To: All Potential Respondents
From: Michael Bradbury – Statewide Procurement Officer
Subject: RFP25CRDLWBGANTO-0015

Addendum One

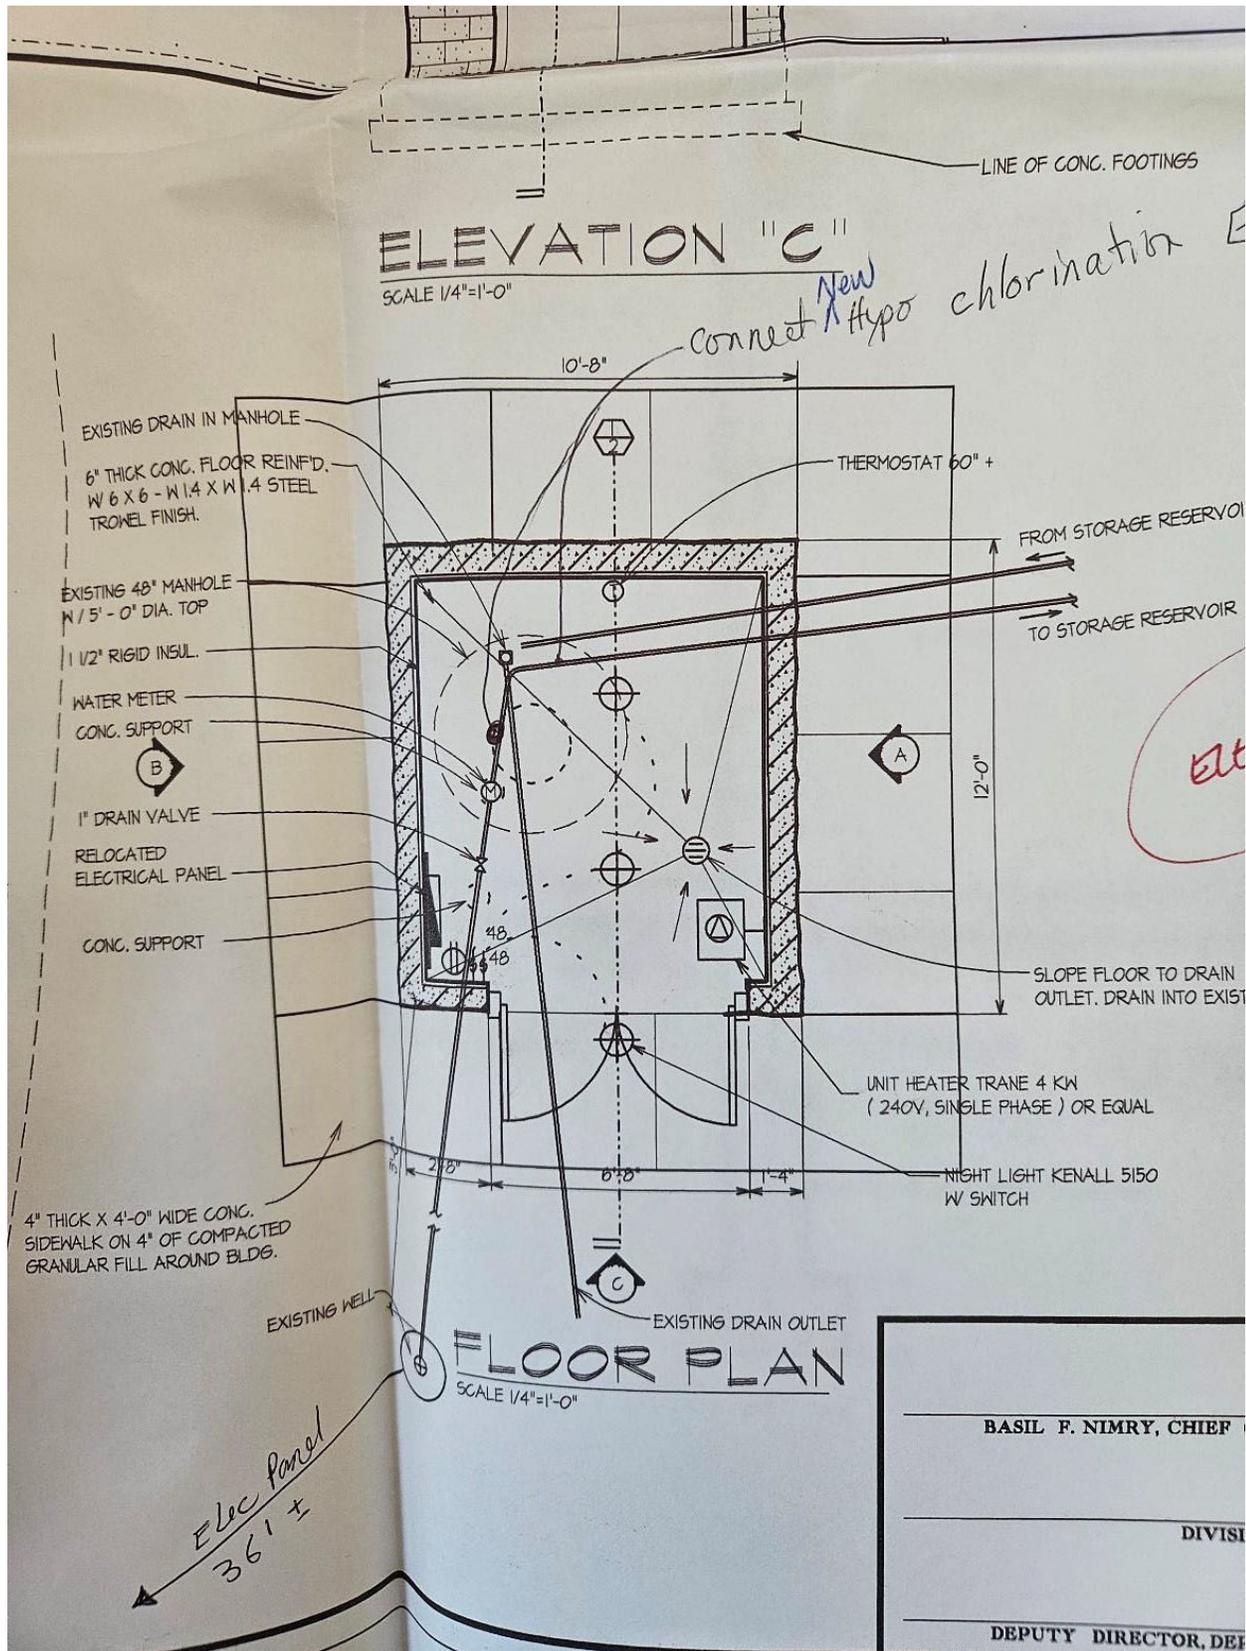
Q) Could DNR provide construction documents for the 2" water line from Reservoir #1 to Flush Hydrant installed in 2014?

A) The DNR could not locate construction documents for the 2014 2" waterline installation. This was considered an emergency repair, and no documents other than an invoice were ever produced. The invoice for this job supports that was a 2" gasket-joint PVC

Well house plumbing images and blueprint

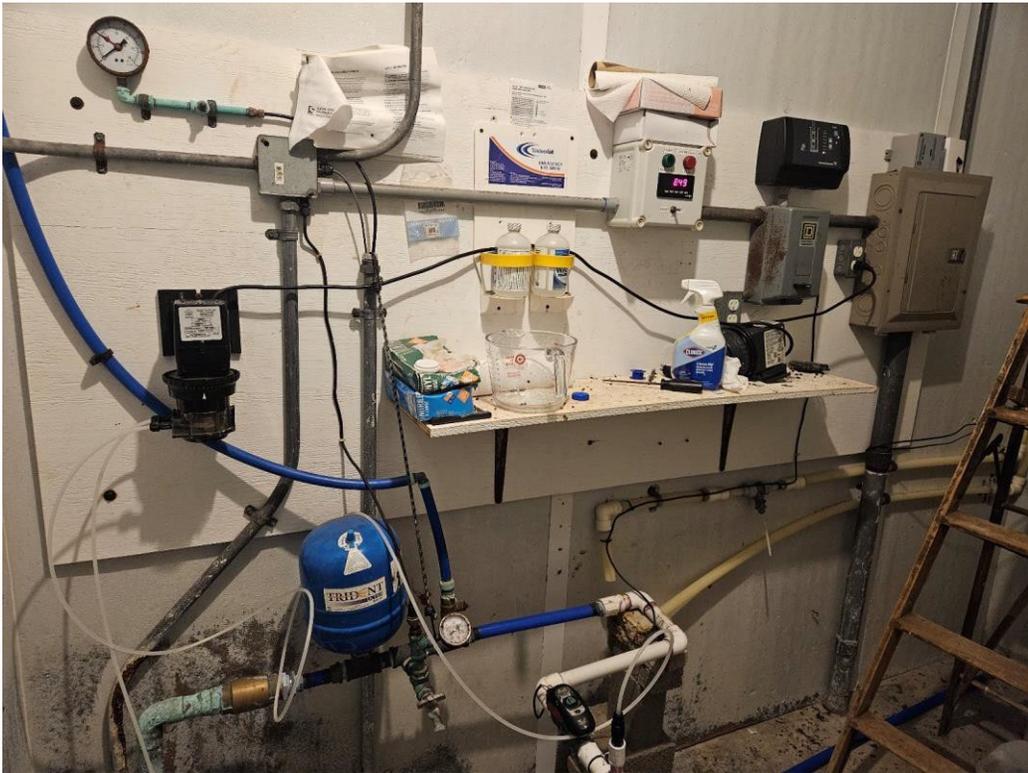
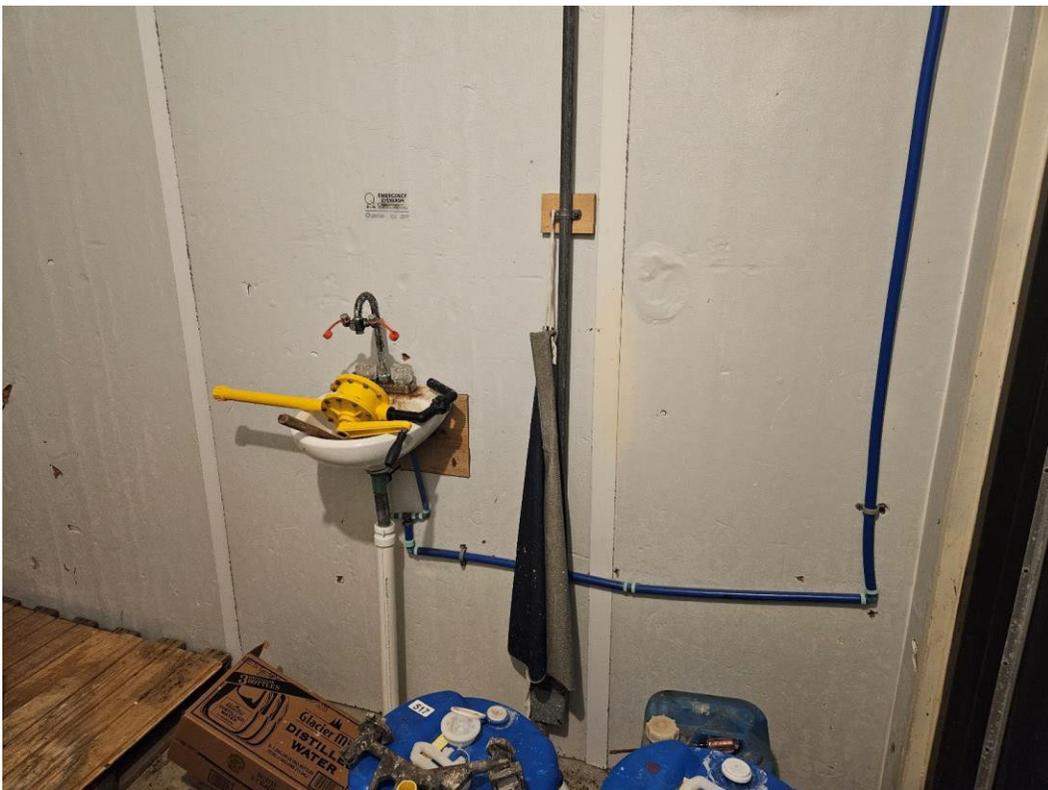
Q) Paragraph 1.5 Background states that replacing all the plumbing inside the existing well building is an identified need. Could DNR provide photos of the interior of the well building or construction documents for the well building?

A) See below photos

Model number for the current well pump (15SQE10-220 Grundfos Submersible Pump)
